Errata

**IWR6843AOP Device Silicon Errata
Silicon Revisions 1.0 and 2.0**

MSS#35 (continued) **EDMA TPTC Generates an Incorrect Address on the Read Interface, Causing one or More Data Integrity Failures, Hangs, or Extra Reads**

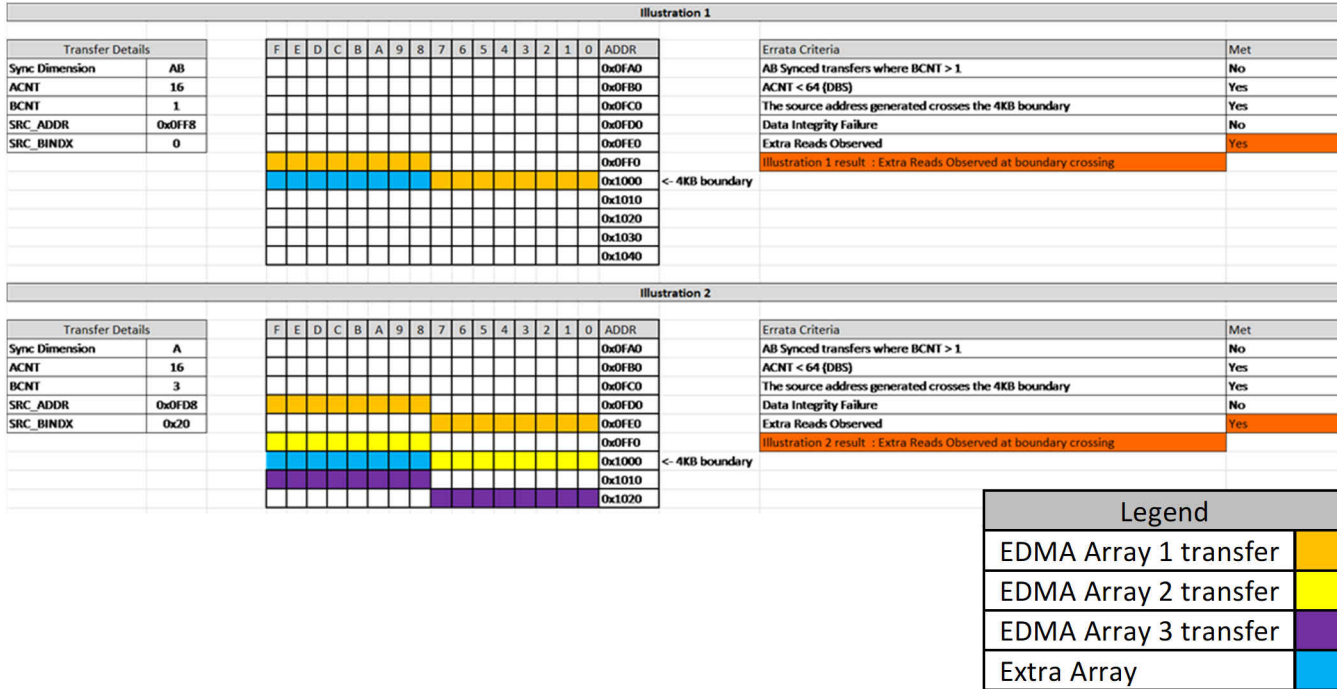
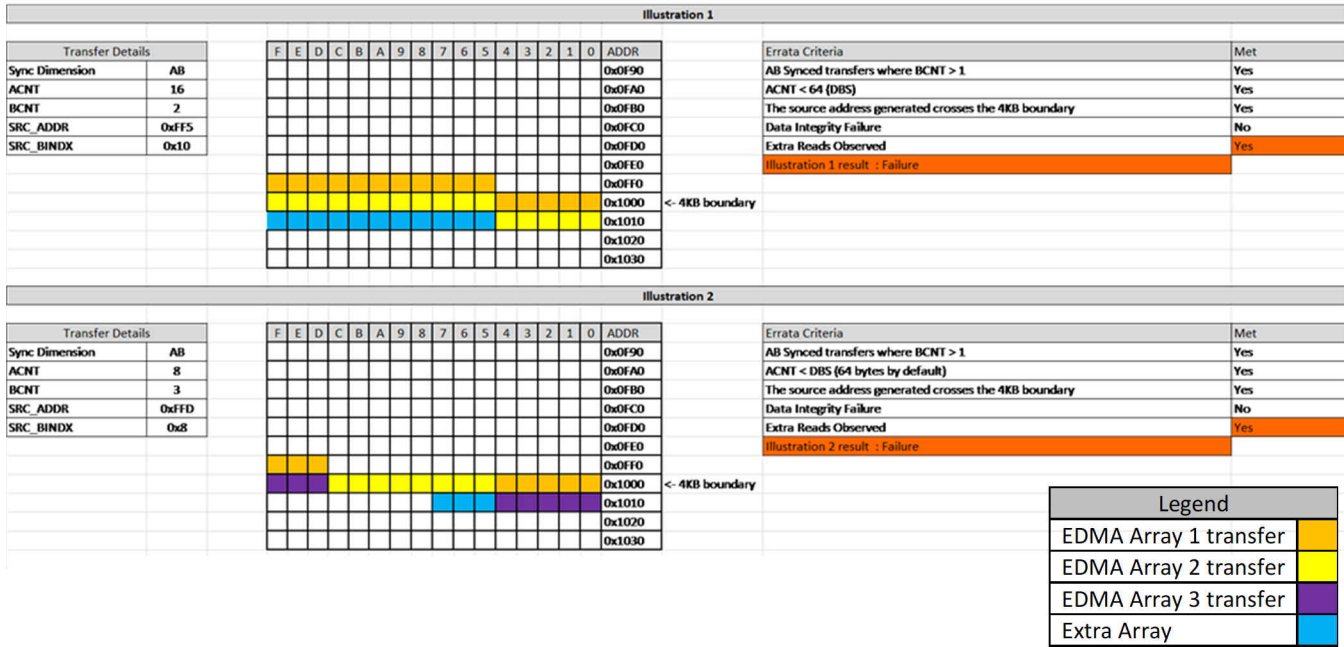
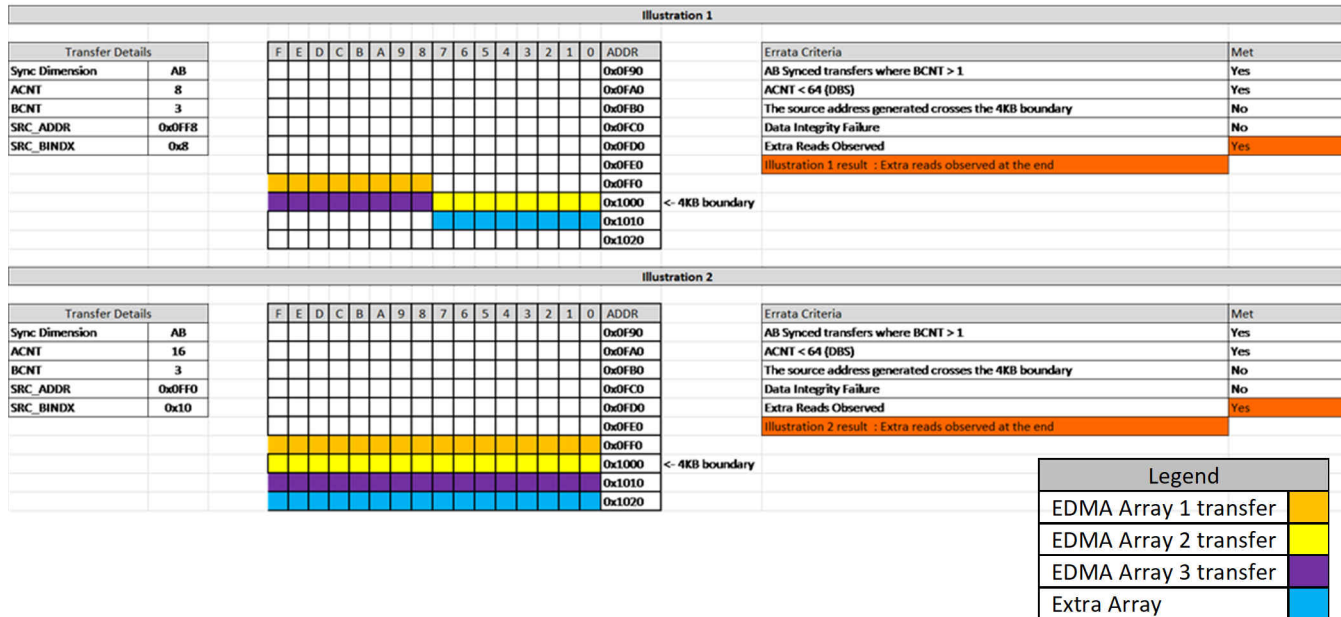
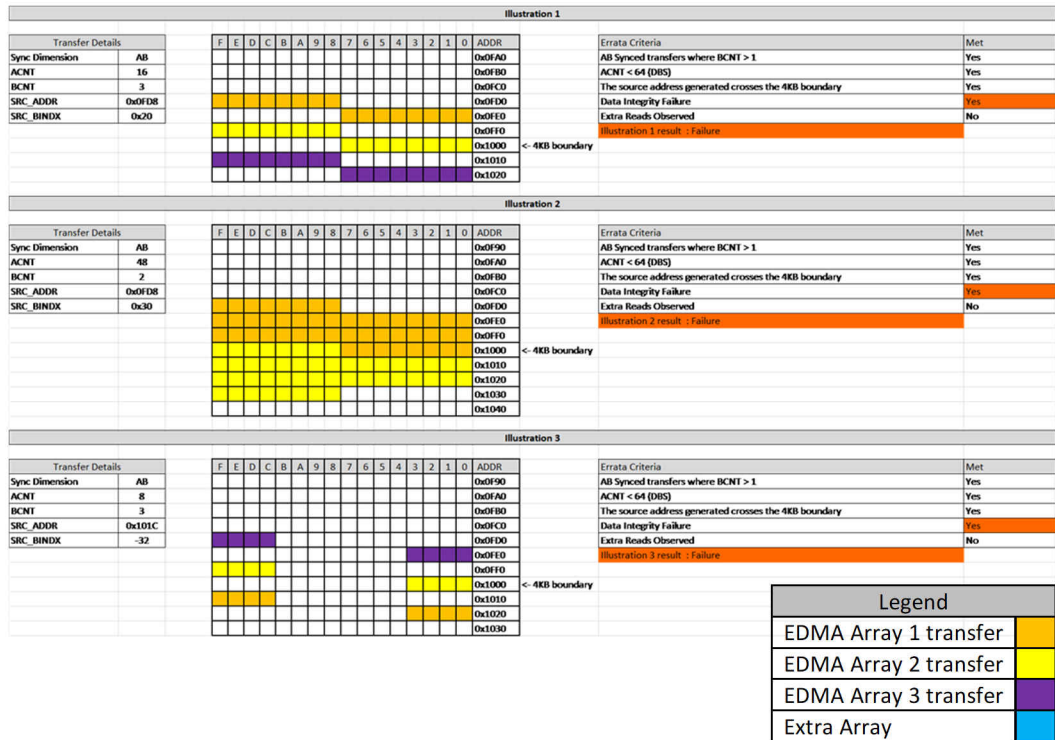
Certain scenarios could lead to an incorrect read, hang, or data integrity issues in the EDMA TPTC block. [Table 6-1](#) shows the various scenarios and the resulting effects of each scenario.

For each extra read in **Scenario ID #3** for which **Condition [1]** is applicable, each index i above that satisfies the condition results in extra read from starting address SRC_ADDR + (i + 1) * SRCBIDX and of length equal to the distance from the start address to the boundary [that is, 0x1000 – X(i)]. Note: length < ACNT.

For each extra read **Scenario ID #4** in for which **Condition [1]** is applicable, there is an extra read from starting address SRC + BCNT * ACNT (=SRCBIDX) of length equal to the distance of the start address to the boundary [that is, length is 0x1000 – X(i)], where i is the index of one and only 4-KB boundary crossing condition. Note: length < ACNT.

For the extra read **Scenario ID #5** in for which [Condition \[2\]](#) is applicable, there is an extra read from starting address SRC + BCNT * ACNT (=SRCBIDX) of length equal to the distance of the start address and is of length ACNT.

Workaround(s): **Workaround #1 - ALL SCENARIO IDs** (see [Table 6-1](#))

Prevent one or more of the conditions necessary for the problematic scenarios to happen.

Workaround #2 - Scenario ID #3, Scenario ID #4, and Scenario ID #5 (see [Table 6-1](#))–**EXTRA READS**

For **Scenario ID #3, Scenario ID #4, and Scenario ID #5**– **EXTRA READS**, another workaround besides avoiding the 4-KB boundary cross conditions, is to ensure that buffers involved in this kind of transfer are positioned so that extra reads stay within the physical memory boundaries. If the extra reads go to Reserved space or space blocked by the Memory Protection Unit (MPU), the TPTC generates a bus error interrupt to the processor.

Figure 6-5. Small form factor board with PCB edge less than 0.3mm

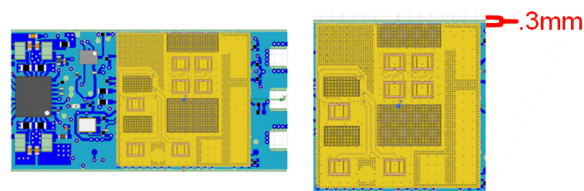
Description: Large PCBs area around the E-plane causes surface waves that create large ripples in the elevation direction of the AoP antenna radiation pattern.

Workaround #1 Keep the Edge of PCB close to the edge of the AoP device in the E-plane to minimize the surface wave ripples.
